STAFF RECOMMENDATION
1109 Porter Road
August 18, 2021

Application: New Construction—Infill and Outbuilding
District: Eastwood Neighborhood Conservation Zoning Overlay
Council District: 06
Base Zoning: R6
Map and Parcel Number: 08303016500
Applicant: Brent Hunter
Project Lead: Melissa Sajid, Melissa.sajid@nashville.gov

Description of Project: Application is to construct infill and an outbuilding that does not include a dwelling unit.

Recommendation Summary: Staff recommends disapproval of the proposed infill and outbuilding, finding that the project does not meet Sections V.A (Massing and Scale) and V.B (Form) of Part I of the consolidated design guidelines for the turn-of-the-century neighborhood conservation zoning overlays.

Figure 5. Proposed front elevation.

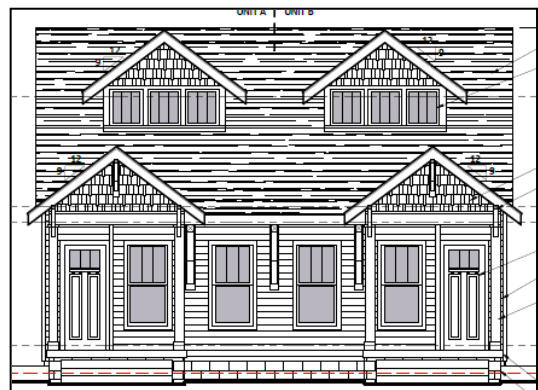
The proposed infill for 1109 Porter Road is twenty-five feet (25') tall and thirty-four feet (34') wide, which matches the maximum height and width of the historic context (Figure 5). The new construction reads as one and one-half stories at the front, but the two-story scale on the side elevations combined with the width of the front dormers as well as the overall height and width push the overall scale to a large one and one-half story infill that is inappropriate for the historic context. The front dormers are each approximately nine feet (9') wide and accommodate triple windows; front dormers on historic homes on this block are smaller and typically accommodate a paired window. With the revised plan, the eaves have been reduced from approximately nineteen feet (19') to seventeen feet (17') (Figures 6-7). Staff finds that the proposed side elevations are still a full two-stories for the majority of the depth of the infill. Furthermore, the depth has increased from approximately ninety-five feet (95') to ninety-seven feet (97').

While a one and one-half story infill would be appropriate for this lot, staff finds that the height and scale of the proposed infill overwhelm the historic context. Since a revised plan addressing staff’s concerns over the height and scale would likely result in a redesign of the project, staff recommends disapproval since the proposed infill does not meet Sections V.A and V.B. of the design guidelines.

Proposed Architectural Site Plan

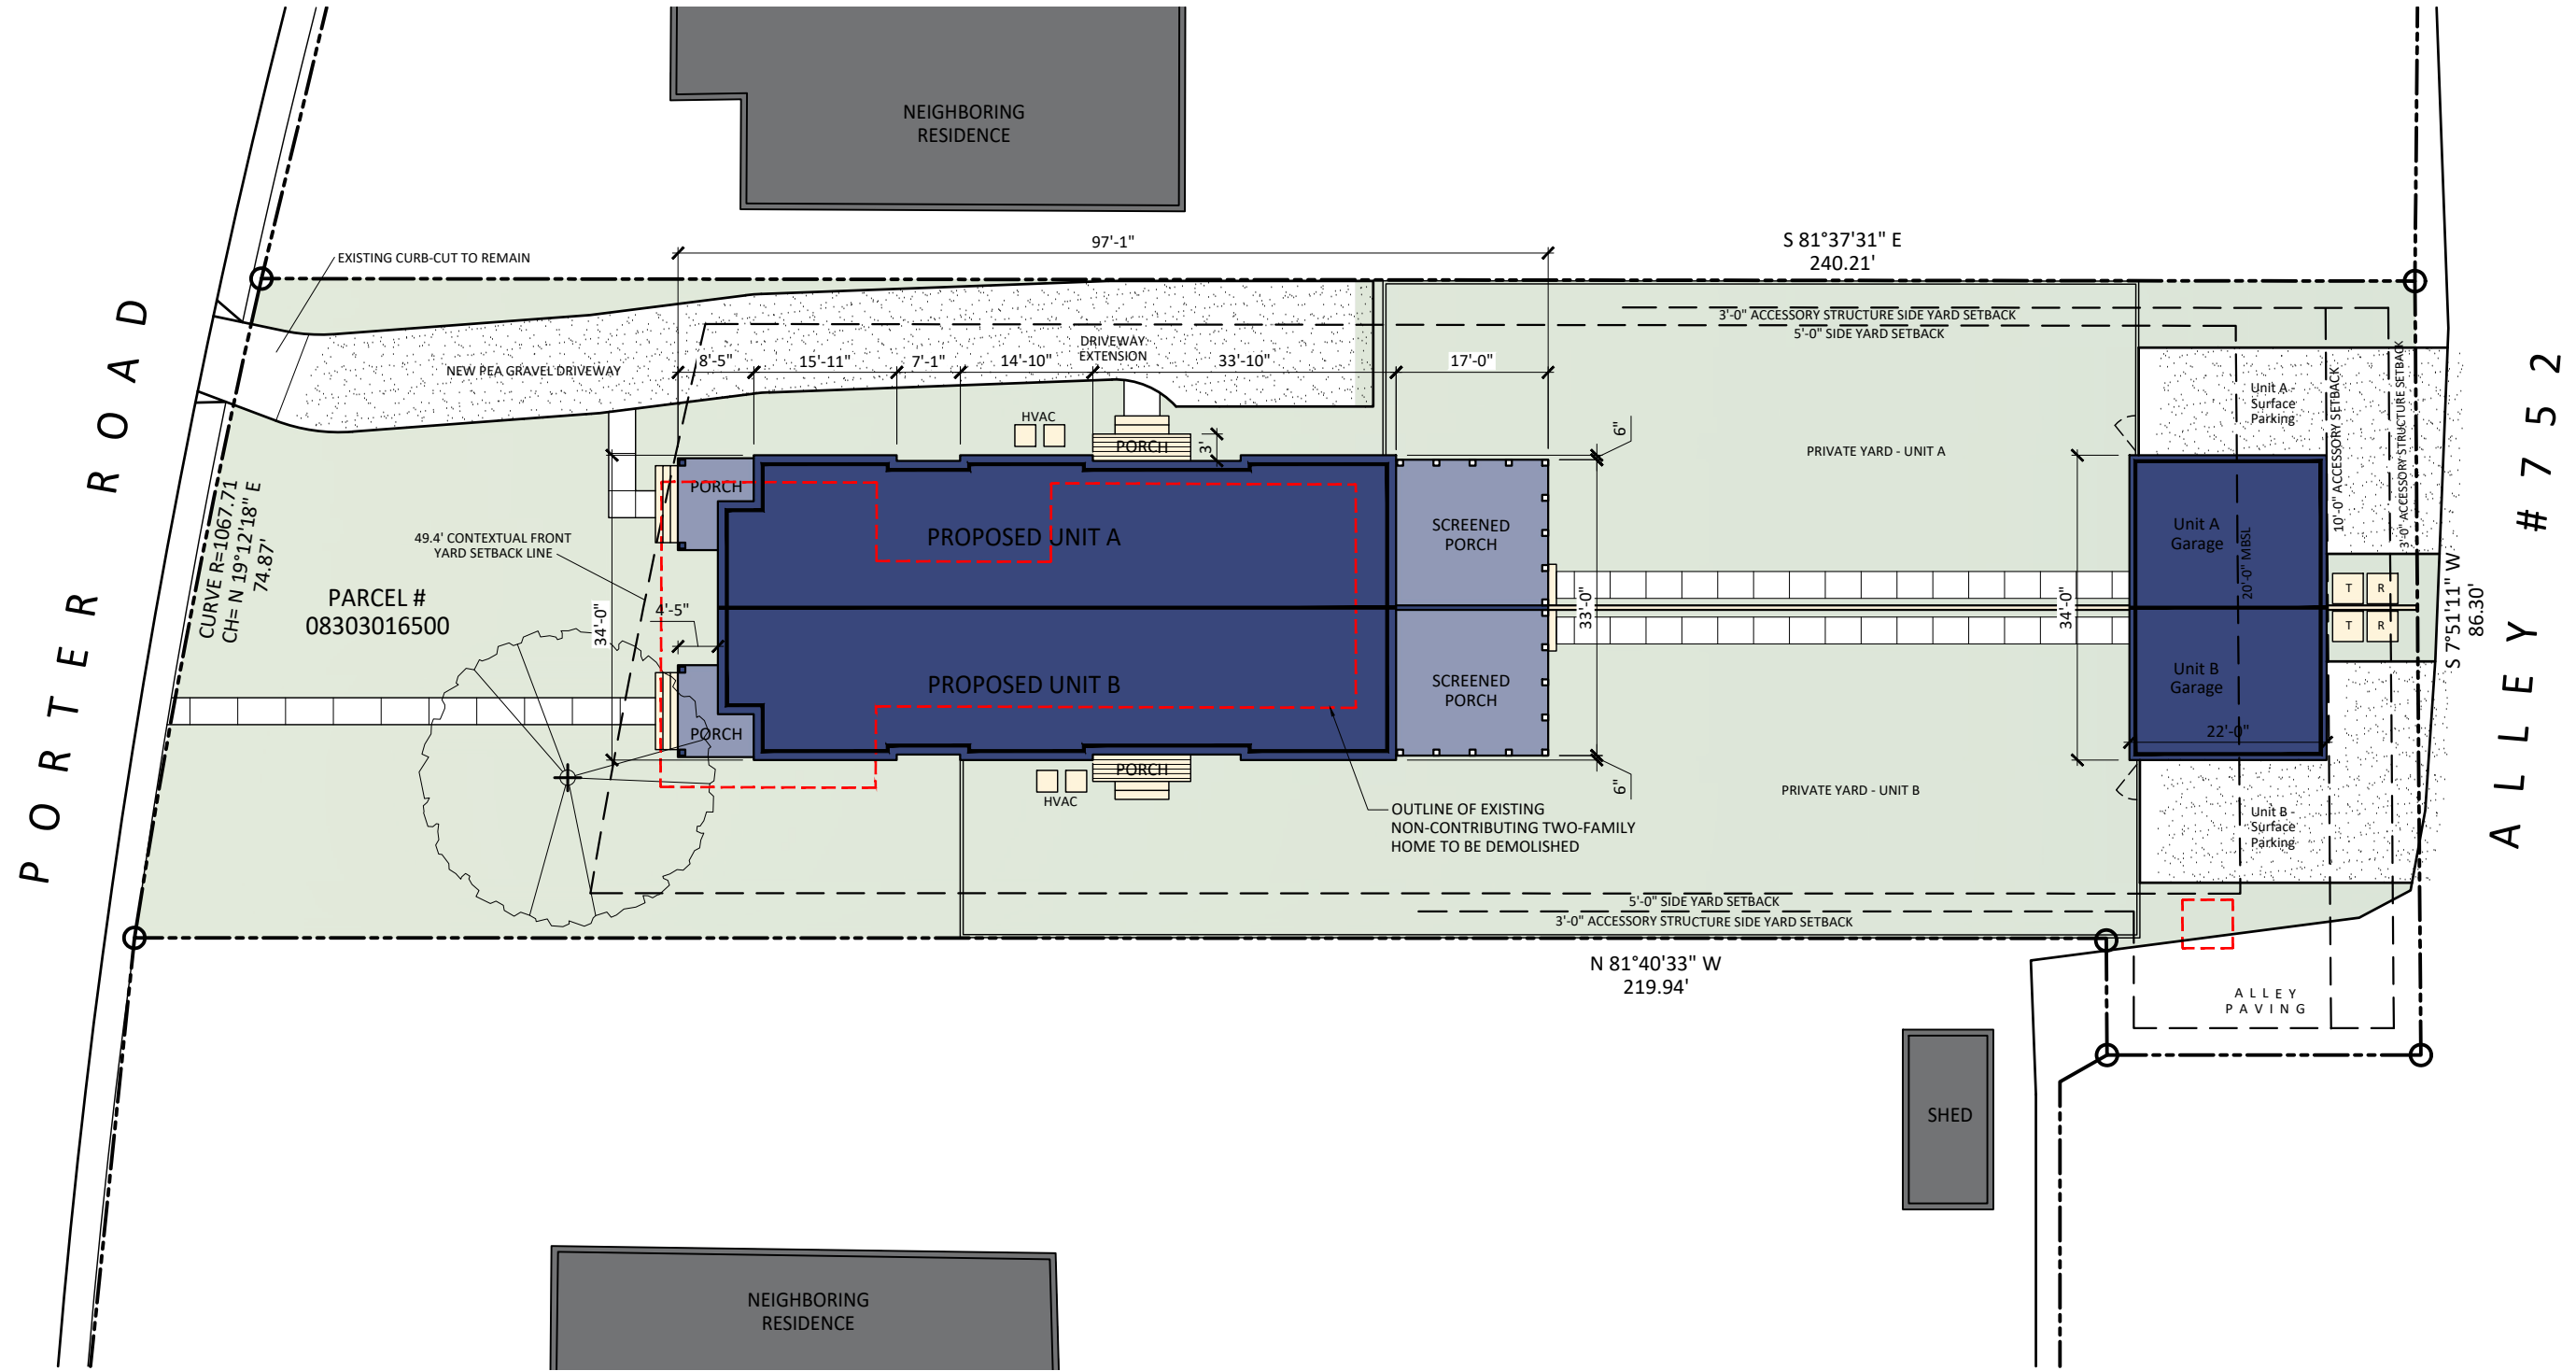
Setback & Rhythm of Spacing: The proposed infill meets all base zoning setbacks. The front porch is approximately forty-nine feet, five inches (49’-5”) from the front property line, which is consistent with the historic house at 1111 Porter Road. The new house is centered on the lot with side setbacks of approximately twenty feet (20’) from both side property lines. The infill has a rear setback of approximately ninety-six feet, five inches (96’-5”).

Orientation: The infill is oriented to Porter Road with a front porch at each front corner that is four feet, five inches (4’-5”) deep. While the design guidelines require that the front porch be at least six feet (6’) deep, staff finds that the proposed porch dimensions could be appropriate since the design is similar to a covered stoop. The site plan indicates that the existing curb cut on Porter Road is to remain, but the front yard parking is to be removed and the driveway extended beyond the midpoint of the infill. The walkway for Unit A ties into the driveway while the front walkway for Unit B ties into the sidewalk along Porter Road. Additional on-site parking is located off the alley at the rear. The project meets Section V.C.

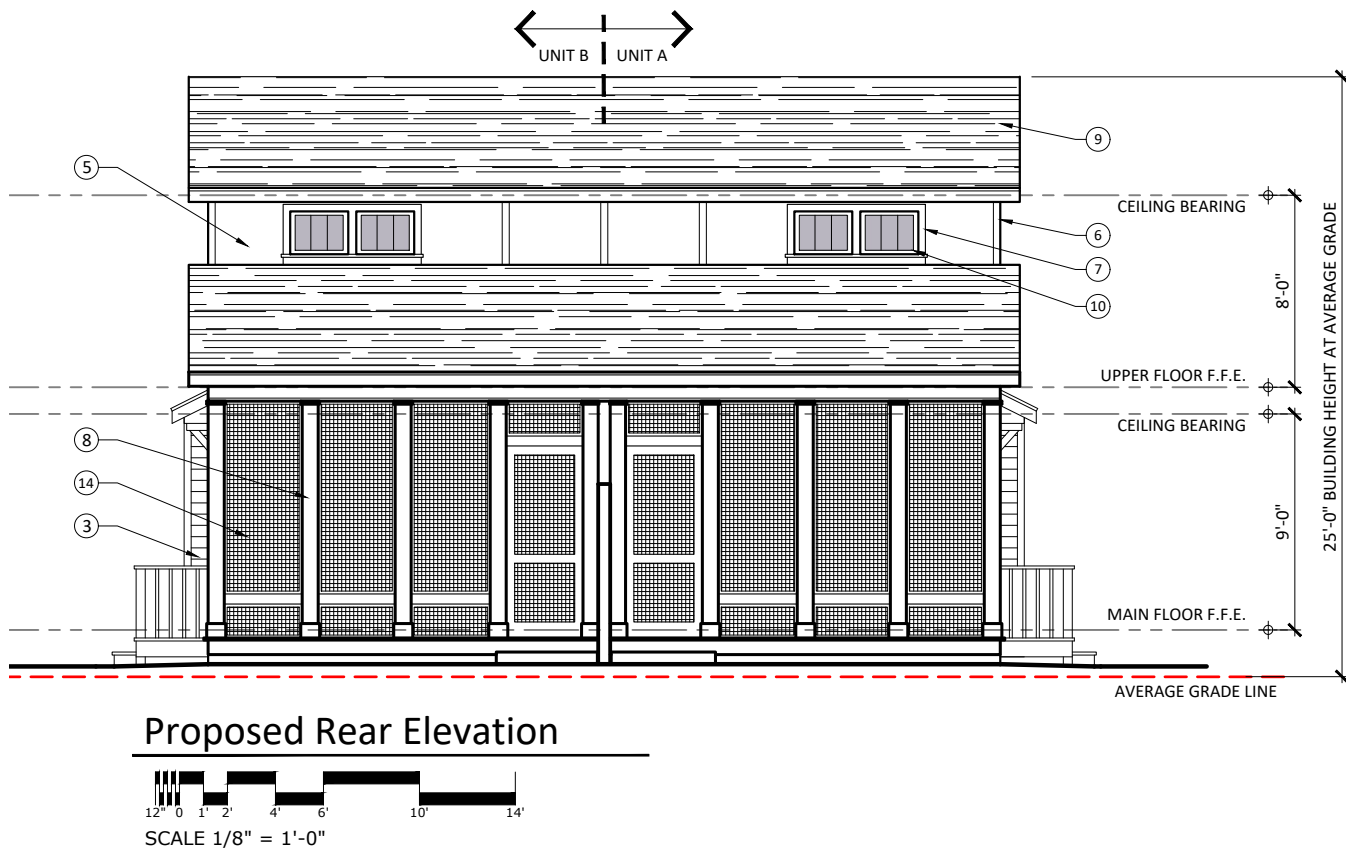
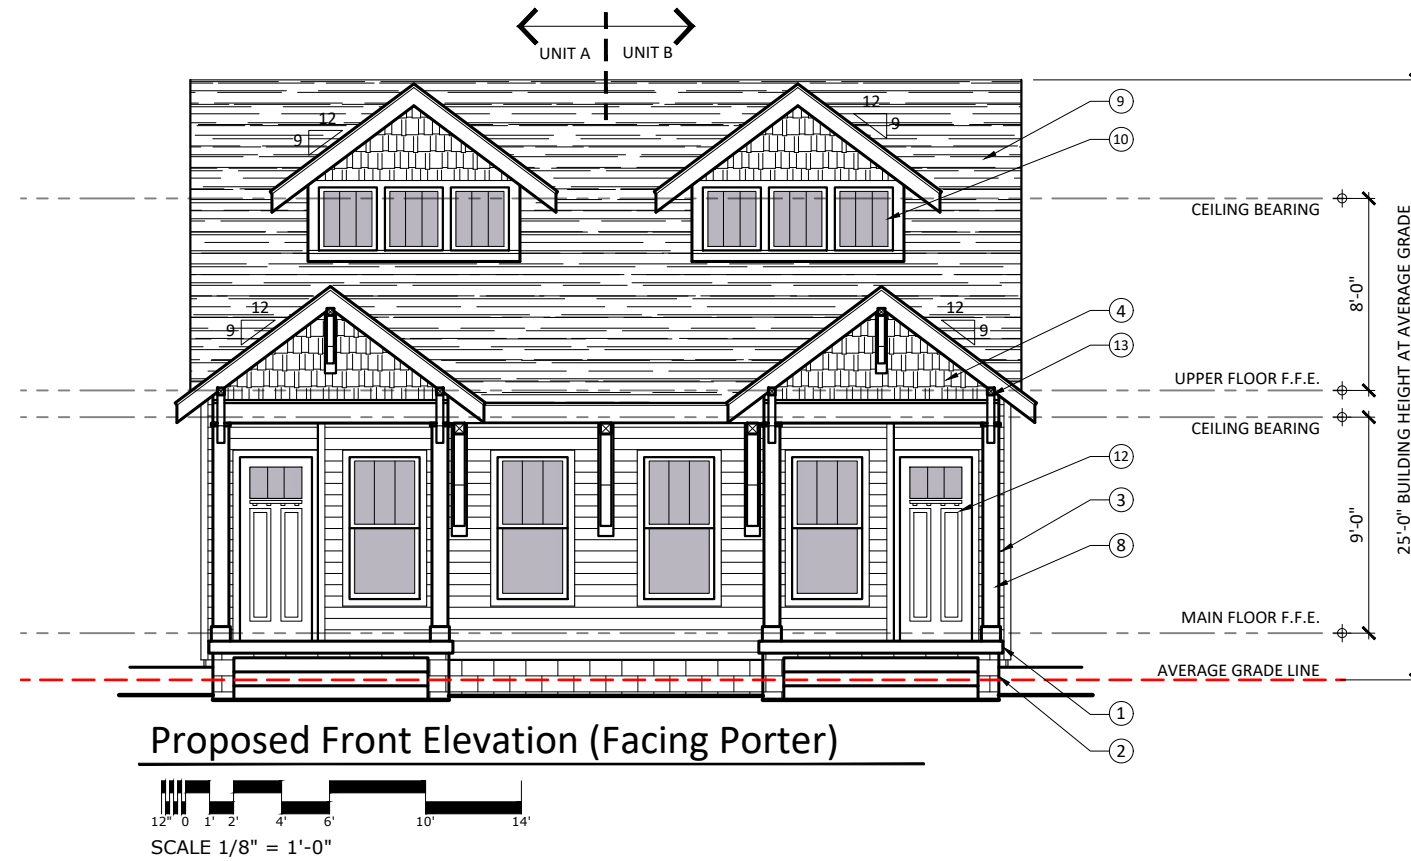
Roof form: The infill has a cross-gabled roof form with a 9/12 pitch. The front dormers, front porch roofs, and side gables are all gabled and also have a 9/12 pitch. The side porches and rear screened porch has a shed roof from with a 3/12 pitch. While the proposed roof forms and pitches can be appropriate for the historic context, staff finds that these elements contribute to the overall scale of the infill which is inappropriate for the historic context. (See “Height & Scale.”)

The project does not meet Section V.B.

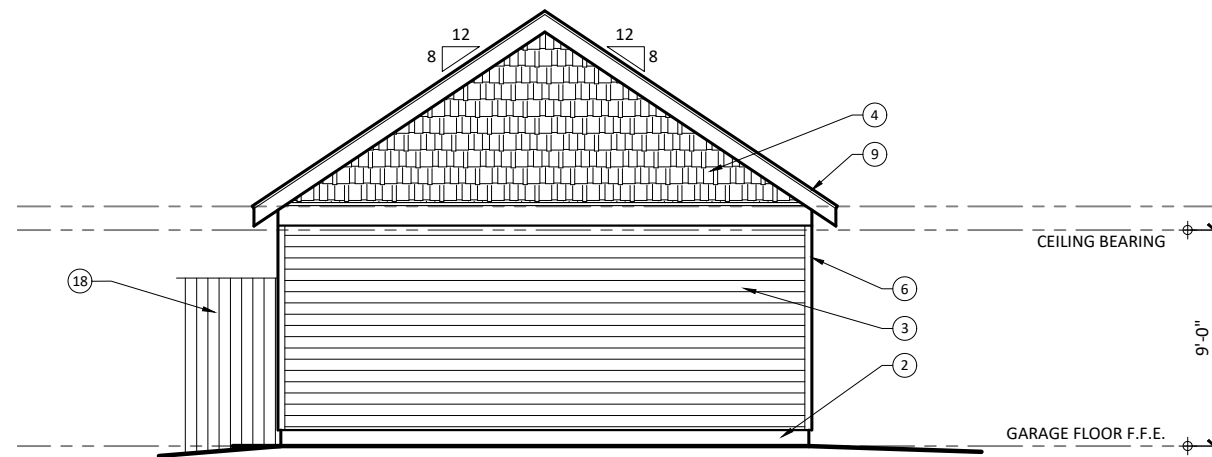
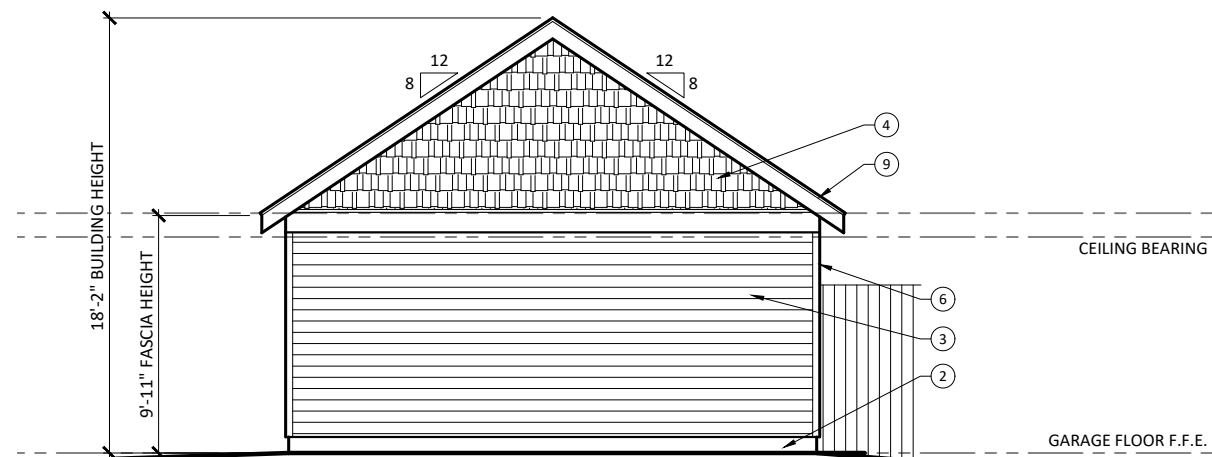
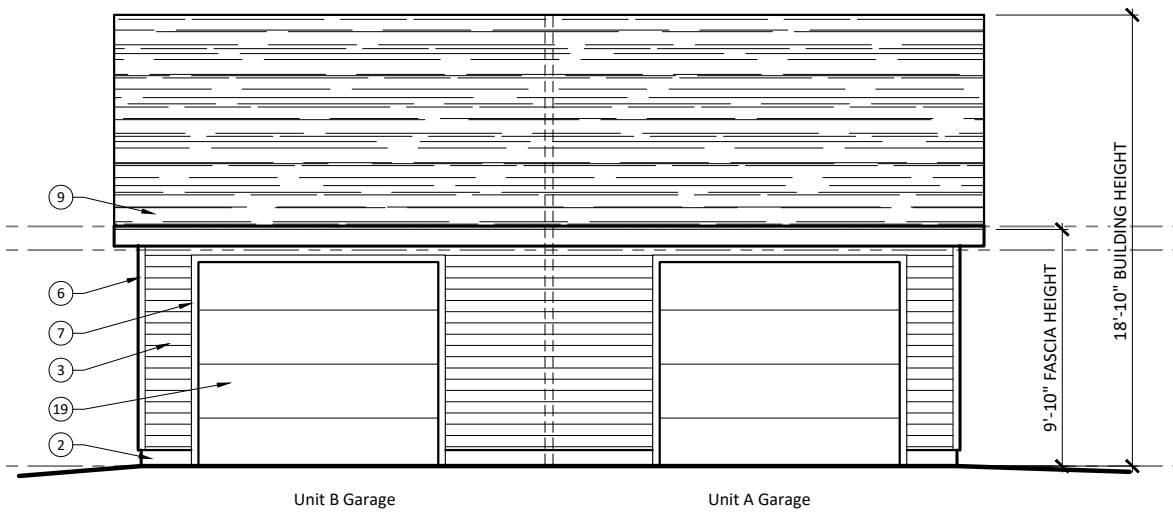
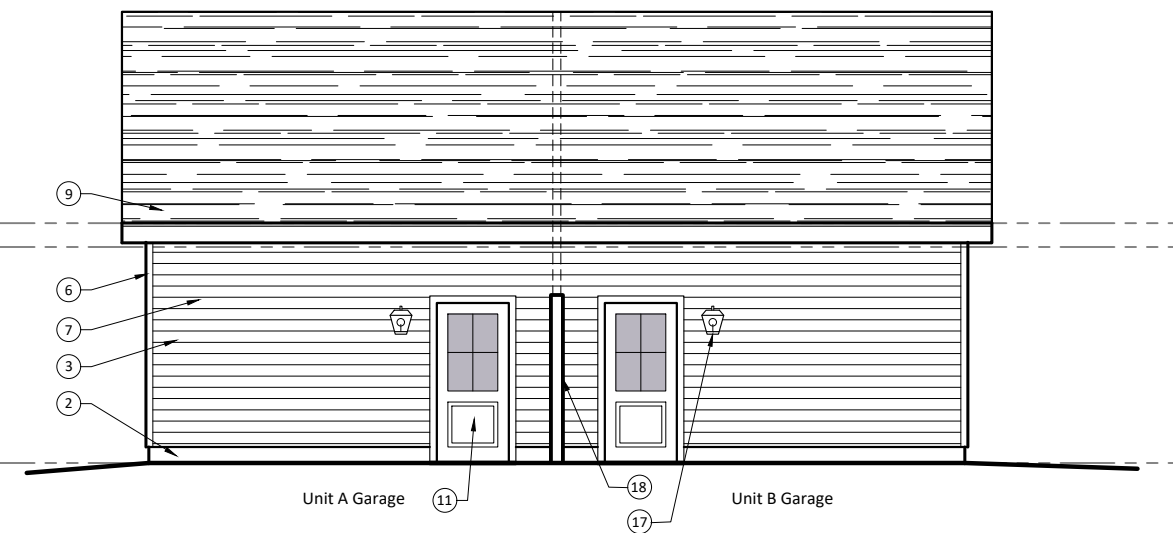
Staff finds that the outbuilding's massing and form to meet Section VII.B. of the of Part I and the Eastwood chapter of Part II. of the consolidated design guidelines for the turn-of-the-century neighborhood conservation zoning overlays

Staff finds that the outbuilding's siting and setbacks to meet Section VII.C. of the of Part I and the Eastwood chapter of Part II. of the consolidated design guidelines for the turn-of-the-century neighborhood conservation zoning overlays.

With staff's final approval of the doors and garage door, staff finds that the materials meet the design guidelines.

Although the outbuilding meets the design guidelines, it is not known how it will compare to a revised infill design, if the current proposal is disapproved. In addition, Codes will not allow for the construction of an outbuilding without a primary building. For those reasons, staff recommends disapproval of the outbuilding as well.
